CITY of NOVI CITY COUNCIL

Agenda Item 2
May 23, 2011

SUBJECT: Consideration to approve the Third Amendment to the SDO Agreement for Cadillac of Novi, previously known as Hummer of Novi, and approval of the amended Preliminary Site Plan, SP11-10 and Stormwater Management Plan. The subject property is located at 41350 Grand River Avenue on the northeast corner of Grand River Avenue and Meadowbrook Road, in Section 24 of the City. The property totals 6.7 acres and the applicant is proposing building additions totaling approximately 2,227 square feet and changes to the existing parking lot layout.

SERVICE CANOPY
 PLANS

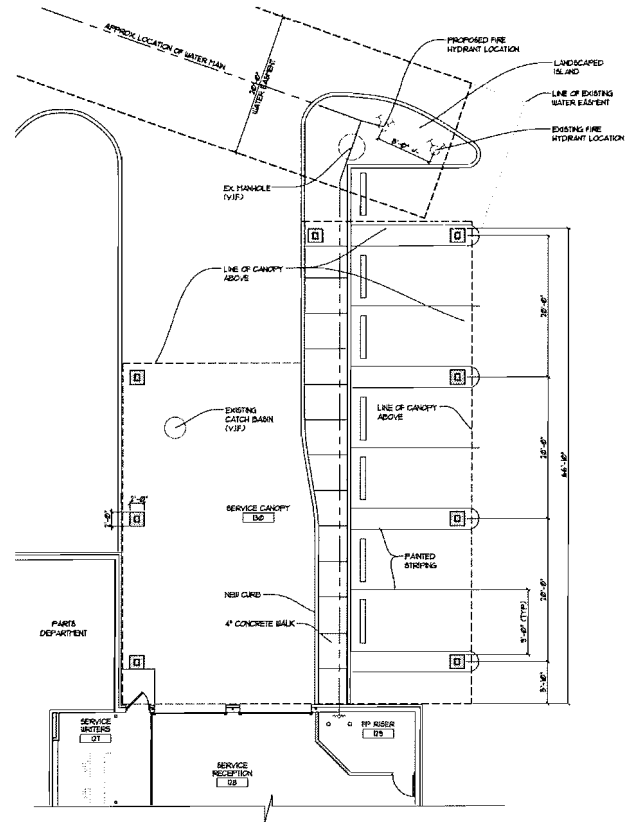
The fire review did not recommend approval noting concerns with the proposed service canopy and service area building addition locations in relation to an existing fire connection and hydrant. The applicant has submitted a revised sketch that shifts the canopy so as not to block either of these connections. The Fire Marshal is satisfied with this solution. These changes will be incorporated into the Final Site Plan submittal. The revised sketch is attached.

**PROPOSED REVISIONS TO ADDRESS
ENGINEERING DIVISION'S AND
FIRE MARSHAL'S CONCERNS**

PLAN NORTH
 1 REVISED CANOPY
 (REVISED 5/03/11) 1/8" = 1'-0"

SOUTHWEST BUILDING ELEVATION
 EXISTING 29 SQ. FT.
 PROPOSED 64 SQ. FT. +/-

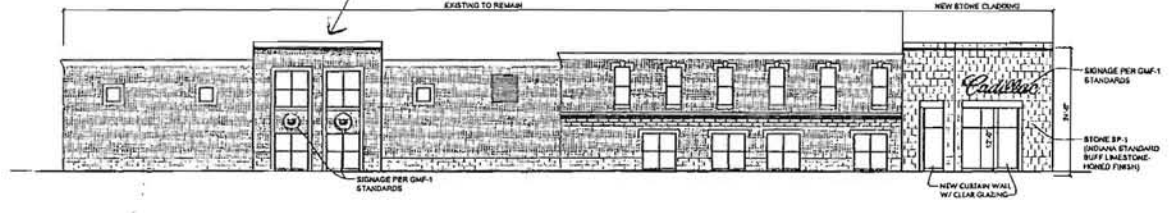
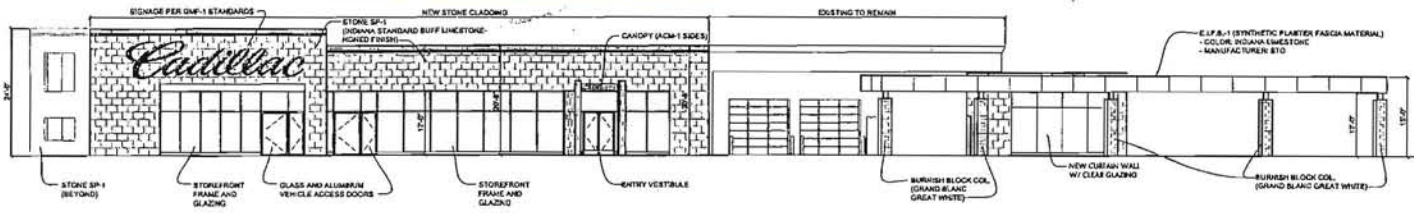
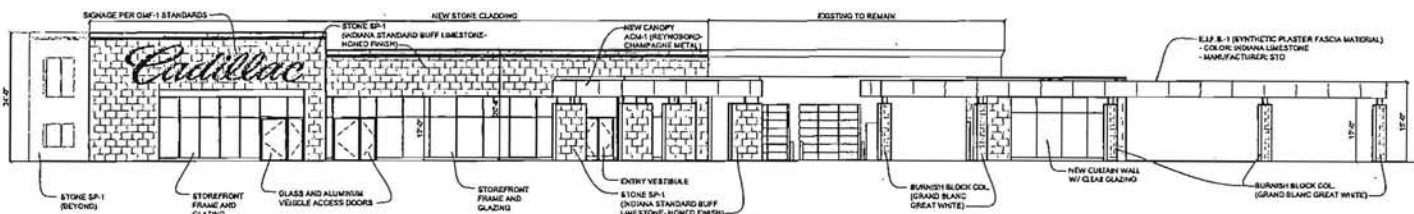
East Bldg Elevation	Southwest Bldg Elevation	West side of building	Screenwall	Entry Monument
Existing	40 square feet	29 square feet	2 medallions @ 6.5 square feet	None	None
Proposed	200 square feet +/- *	64 square feet +/- *	No change proposed	3.5 foot diameter crest +/- on Grand River Ave. *	2 signs @ 35 square feet per sign, one on Meadowbrook Road and one on Grand River Avenue
Permitted	One sign permitted, either wall sign (maximum of 65 square feet) or ground sign (maximum of 35 square feet). Small directional signs are also permitted.

Approval of the modified signage plan is **not recommended**. Staff cannot recommend approval of the additional signage as proposed, since it greatly exceeds ordinance standards for the GE, Gateway East District, and exceeds what was previously approved by the City Council in the Second Amendment to the SDO Agreement. Staff believes that sufficient signs exist on the site to adequately provide notice of the business to the public.
